PCN – Product Change Notification

Document No	PCN-A-080602	Revision	1.0		
-------------	--------------	----------	-----	--	--

ECN Topic: New 8.4 inches Rear Mount Dimension

New Mechanical Dimension:

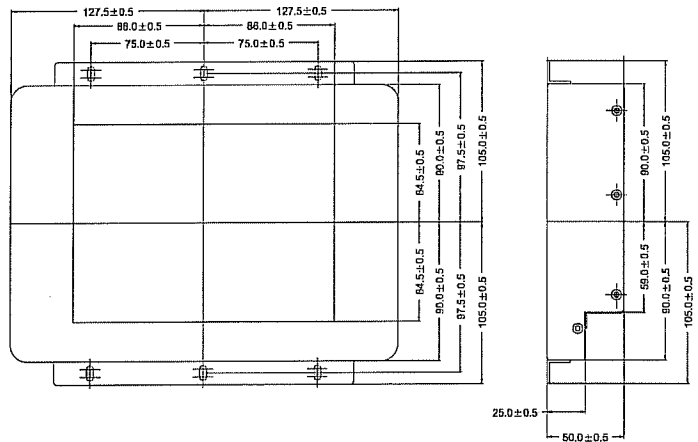
We will release new dimension for 8.4" Rear Mount LCD. The dimension of mechanical will change from 230 x 180 x 45 mm to 255 x 180 x 50 mm and change the position of OSD to the back side.
